ALERT SERVICE BULLETIN

412CF-14-56

MODEL AFFECTED: 412CF

SUBJECT: MAIN ROTOR DRIVE, ENGINE-TO-TRANSMISSION DRIVE SHAFT RETAINING NUTS REPLACEMENT OF.

Figure 1. Main drive shaft attaching nuts.

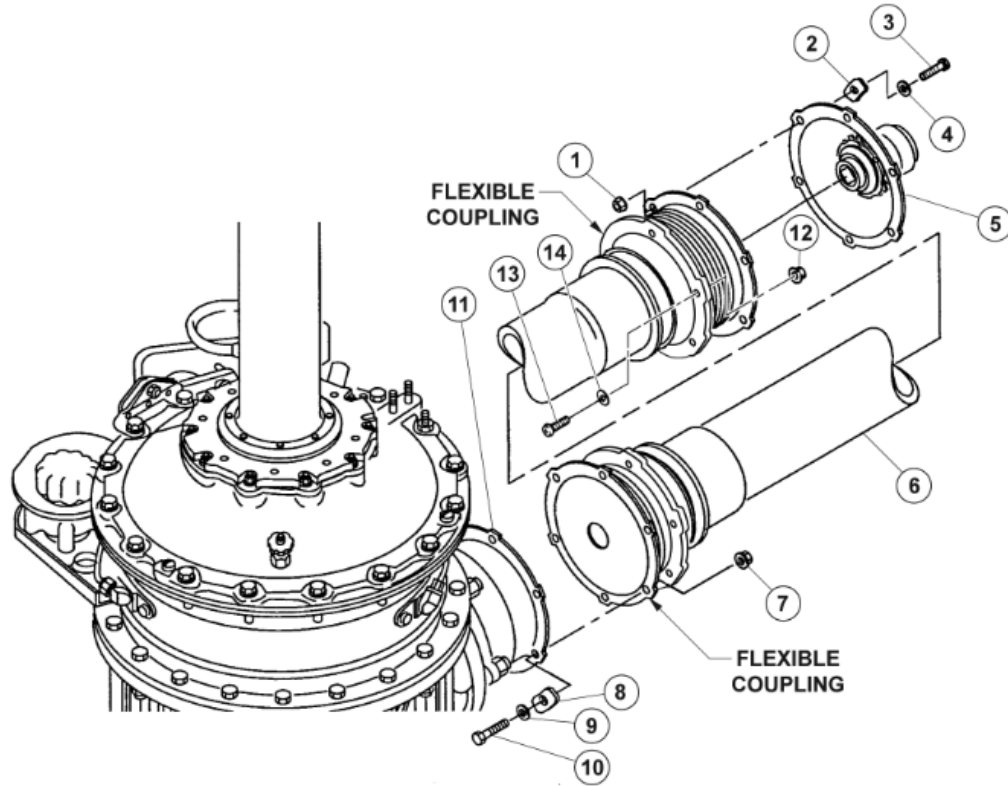
Revision B of this bulletin introduces the new Bell standard nut discussed in the Revision A of this bulletin. The new Bell standard nut is now available as P/N 90-132L4. Due to the general supersession that took place in the Illustrated Parts Breakdown (IPB), it is possible that some operators installed NAS9926-4L nuts as a replacement to the MS21042L4 nuts on the main drive shaft or at the drive coupling to main drive shaft attachment. This bulletin Revision B mandates the replacement of all MS21042 or NAS9926 nuts used in the main drive shaft assembly and main drive shaft installation with the new Bell standard 6-flat nut P/N 90-132L4. The Bell standard nut 90-132 nut is physically similar to the MS21042 nut except that the 90-132 part number is marked at the base of the nut.

1. Gain access to the main drive shaft and replace the currently installed main drive shaft and main drive shaft attaching MS21042L4 or NAS9926-4L nuts (Figure 1, items 1, 7 and 12) with nuts P/N 90-132L4 (C-12-146-000/MF-001).
2. Make an entry in the helicopter logbook and historical service records indicating compliance with this Alert Service Bulletin Revision B.
